December 19, 2024

NOTICE OF VIOLATION

INSPECTION REPORT

Electrical Corporation:	Southern California Edison Company
Report Number:	CADSCE_CAC12_20240813_1110
Inspector:	CAC12
WMP Year Inspected:	2023
Quarterly Data Report (QDR) Referenced:	Quarter 4 (Q4)
Inspection Selection:	Energy Safety viewed the contents of the Q4 QDR and performed an analysis that resulted in the selection of the WMP initiatives and locations referenced in this report.
Relevant WMP Initiative(s):	8.1.2.1.1 Covered Conductor
Date of inspection:	August 13, 2024
City and/or County of Inspection:	Palmdale, Los Angeles County
Inspection Purpose:	Assess the accuracy of Southern California Edison Company's QDR data, completeness of its work, compliance with WMP requirements, and compliance with its protocols.

Item1G1mg1: Overall Pole

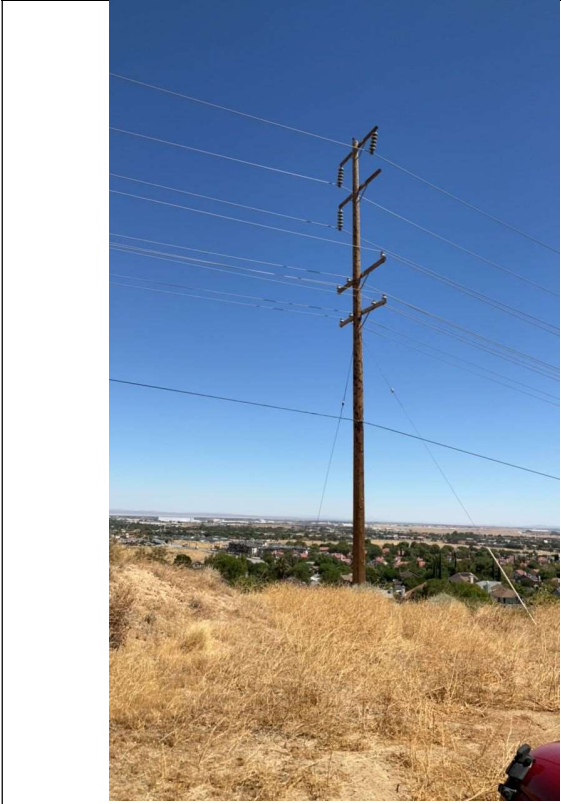
On Pole ID 2297288E, Grid Hardening ID TD1814478-2297288E, at 156 Mountainside Dr, Palmdale, CA 93550, USA, 34.565135, -118.131614, the inspector observed that no covered conductor was present. The inspector's observation is documented in Violation 1 photographs, which are attachments to this report. Photo numbers Item1IA1Img2 and Item1IA1Img3 depict that no covered conductor was installed at the location, additionally the photo number Item1IA1Img1 depicts crossarms on the ground left next to the pole.

1. Southern California Edison Company's 2023 WMP Covered Conductor (8.1.2.1.1) work was identified as complete at this location.
2. Covered conductor was not installed.
